Subject: UniStar Nuclear Energy, NRC Docket No. 52-016
Response to Request for Additional Information for the
Calvert Cliffs Nuclear Power Plant, Unit 3,
RAI No. 284, Vibratory Ground Motion

**Response to NRC Request for Additional Information
RAI No. 284, Question 02.05.02-22, Vibratory Ground Motion
Calvert Cliffs Nuclear Power Plant, Unit 3**

Question 02.05.02-22

Figure 1: 1-Hz Hard Rock Hazard Curves for the New Madrid Seismic Source Zone (NMSZ), the Charleston Source, and the Total Hazard of the CCNPP Unit 3 Site.

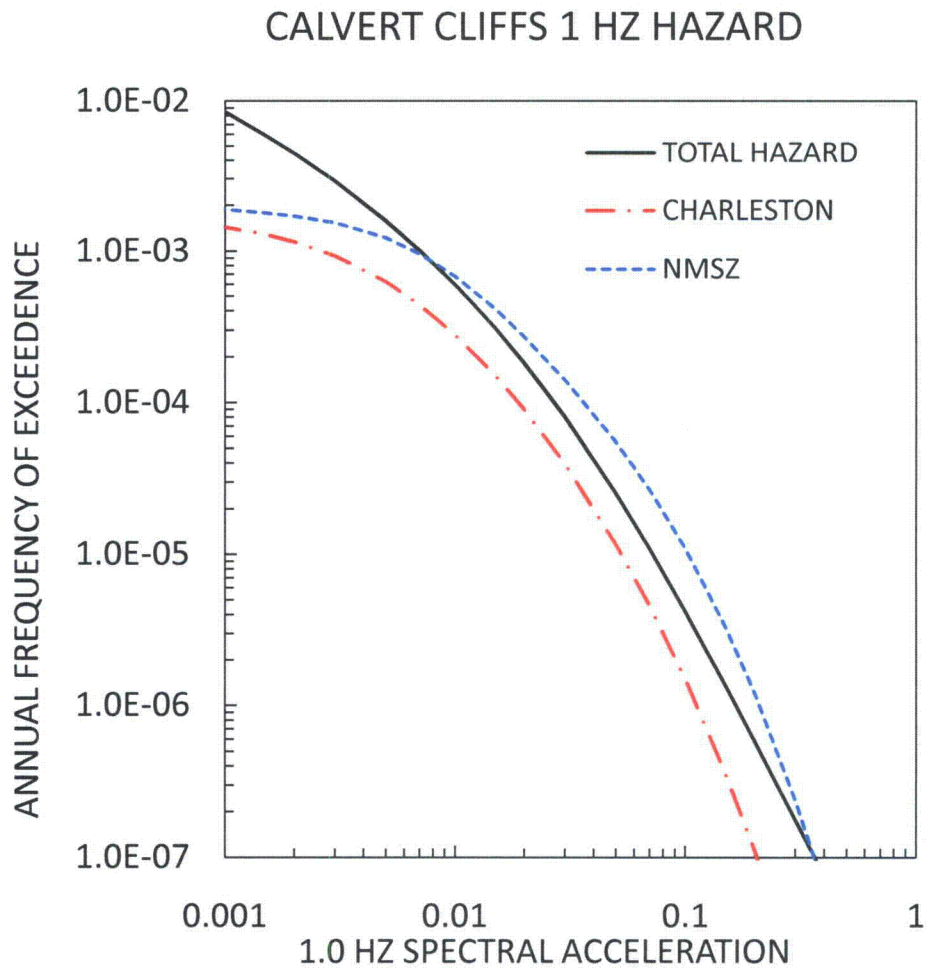
In response to Question 2.5.2-5, which asks what impact the New Madrid Seismic Zone (NMSZ) may have on the CCNPP seismic hazard curves, UniStar stated that the NMSZ is 1200 km away from the site. UniStar did not include the NMSZ in its PSHA study because the EPRI (2004) ground motion prediction equations are defined only up to a distance of 1000km and the Modified Mercalli Intensity (MMI) value of IV at the CCNPP site during the 1811 NMSZ earthquake did not include damage to buildings. Even though the NMSZ is quite distant from the site, a preliminary confirmatory analysis by the NRC staff indicates that the NMSZ may contribute significantly to the 1-Hz hazard. Please provide and compare the 1-Hz hard rock hazard curves for the NMSZ, the Charleston source, and the total hazard of the CCNPP Unit 3 site.

Figure 1 provides and compares the 1.0 Hz hard rock hazard curves for the New Madrid Seismic Source Zone (NMSZ), the Charleston source, and the total hazard of the Calvert Cliffs Nuclear Power Plant (CCNPP) Unit 3 site. It is concluded that the NMSZ has a contribution to the hazard at low frequencies. UniStar is evaluating the cumulative impacts of the NMSZ on the CCNPP Unit 3 FSAR and will provide an update to any impacted COLA content once those impacts are identified.

The FSAR will be updated to incorporate the NMSZ into the CCNPP Unit 3 Probabilistic Seismic Hazard Analysis and its impact to the Ground Motion Response Spectra, as well as any collateral COLA effects. A schedule for submittal of these COLA markups will be provided by August 30, 2011.
